**RESOLUTION MEPC.397(83)**  
**(adopted on 11 April 2025)**

**AMENDMENTS TO THE TECHNICAL CODE ON CONTROL OF EMISSION  
OF NITROGEN OXIDES FROM MARINE DIESEL ENGINES  
(NO<sub>x</sub> TECHNICAL CODE 2008)**

**(Use of multiple engine operational profiles for a marine diesel engine,  
including clarifying engine test cycles)**

**"Appendix IX – Flow chart for engine certification test cycle determination**

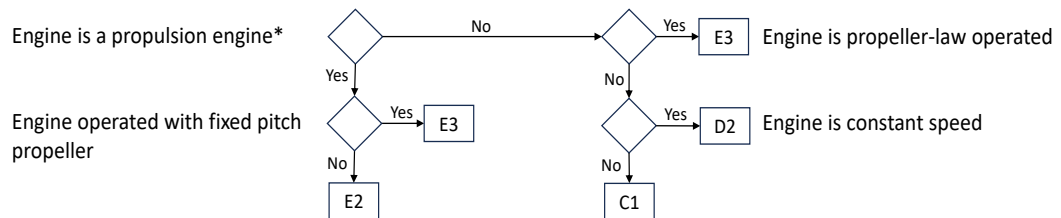
16 A new appendix IX is added as follows:

*(refer to 3.2 of the Code)*

Test cycle selection flowchart

\* A propulsion engine may additionally perform non-propulsion duties during or separately to propulsion duties.  
 An engine that solely or in part provides athwartships movement of a ship is not a propulsion engine.
